# **Permanente Creek Flood Protection Project**

## **Fifth Addendum to the Final Subsequent Environmental Impact Report**

February 2020

Figure 1: New Pedestrian Pathway at McKelvey Park.

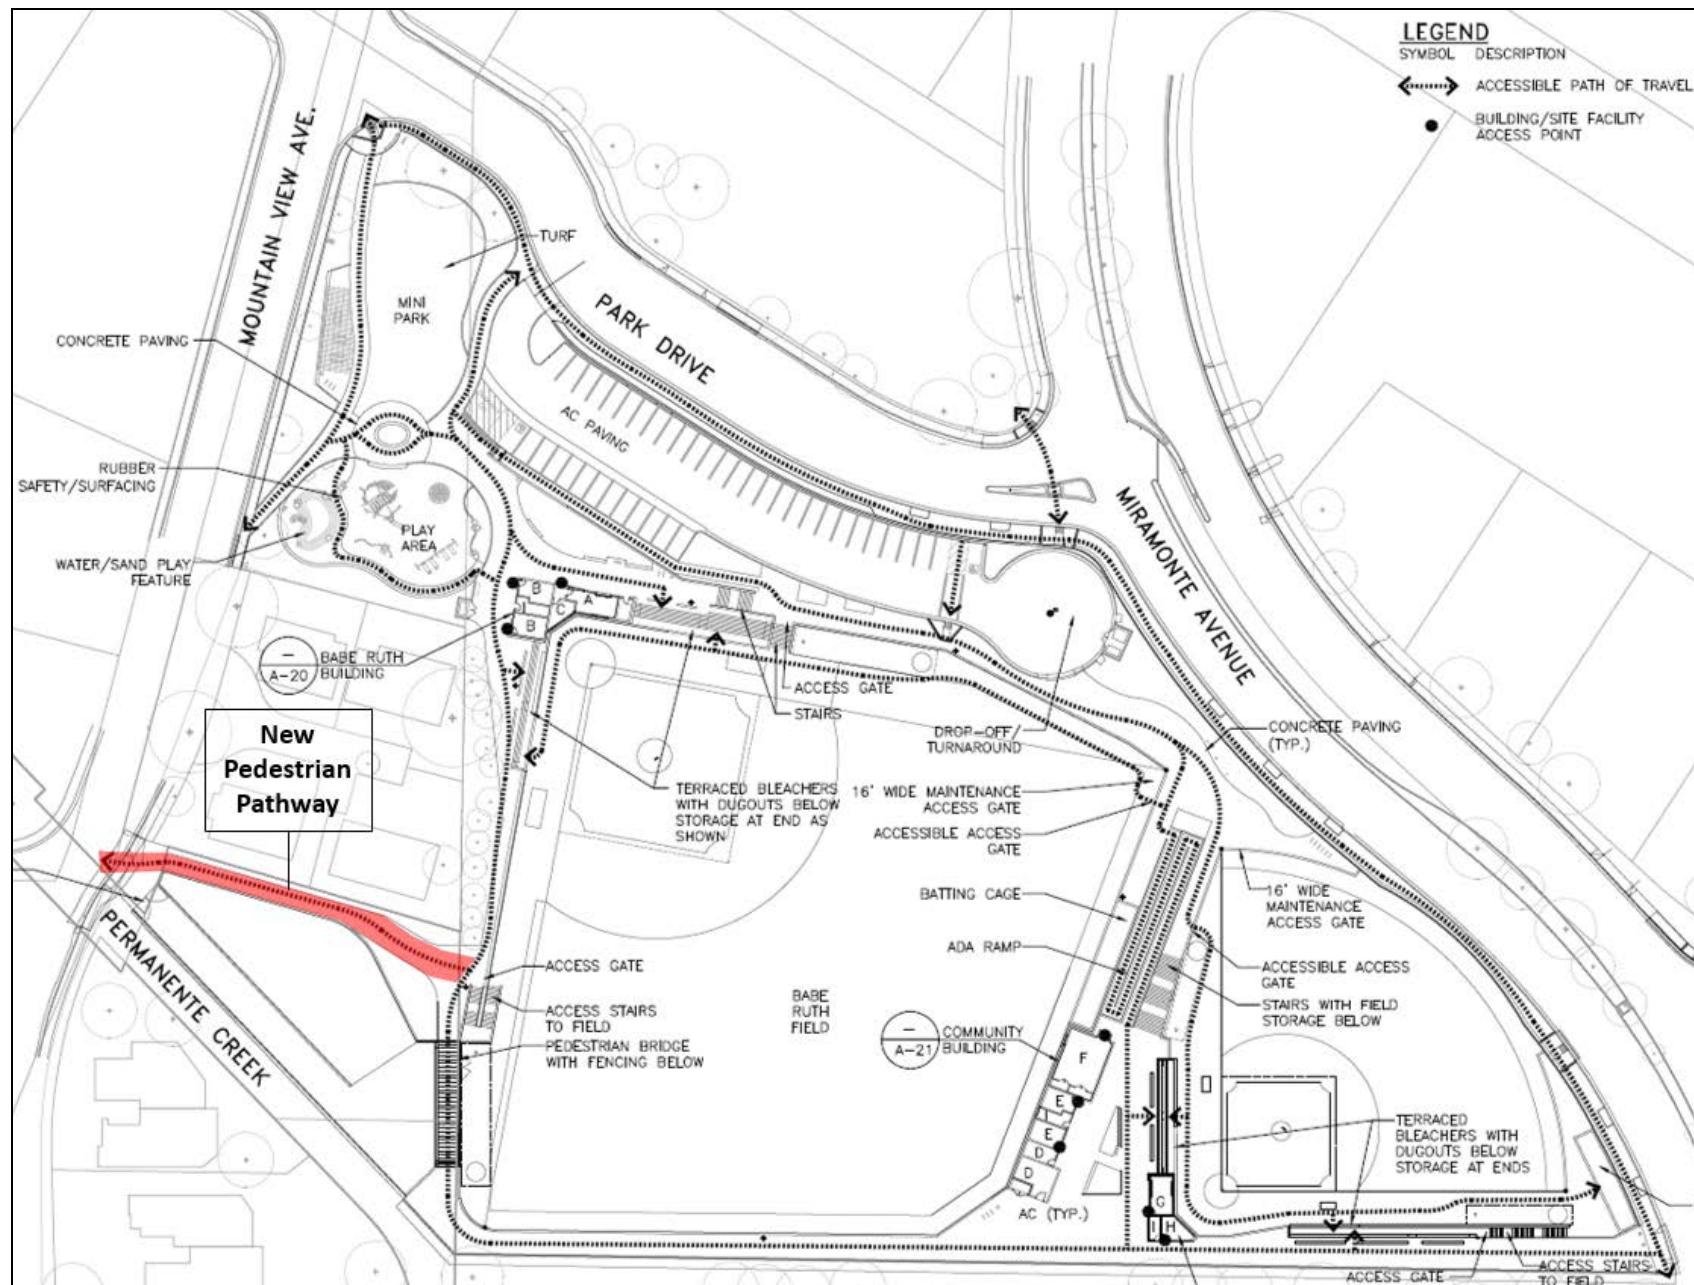
Valley Water proposes minor modification to the project design at the McKelvey Park Detention Facility in Mountain View to construct an additional approximately 200 feet of pedestrian/bicycle pathway (Figure 1). The pathway would be located on the western side of the project area near the floodwall on Permanente Creek and adjacent to residential properties (923 Mountain View Avenue and 1295 Abraham Court). The parcel on which the pathway would be located (assessor's parcel number 18903041) was acquired by Valley Water subsequent to the 2012 EIR and is described in the first Addendum to the EIR, which allowed for extension of the detention basin adjacent to Permanente Creek.

The approximately 200-foot long pedestrian/bicycle pathway would be approximately 7 feet wide and would run in the east-west direction extending from Mountain View Avenue (west end) to its intersection with a previously proposed pathway running in the north-south direction along the west side of Babe Ruth Field (east end). The previously proposed pathway connects to other parts of McKelvey Park including the Little League Field to the east and the play area, mini-park, and parking lot to the north.

There would be a 6-foot tall black vinyl coated chain-link fence along the south side of the pedestrian/bicycle pathway adjacent to the detention basin. Bollards (short sturdy posts) with downward-facing lights would be installed along the south side of the path to light the path during early morning and evening hours. The light bollards are designed to prevent light spillover to adjacent properties.
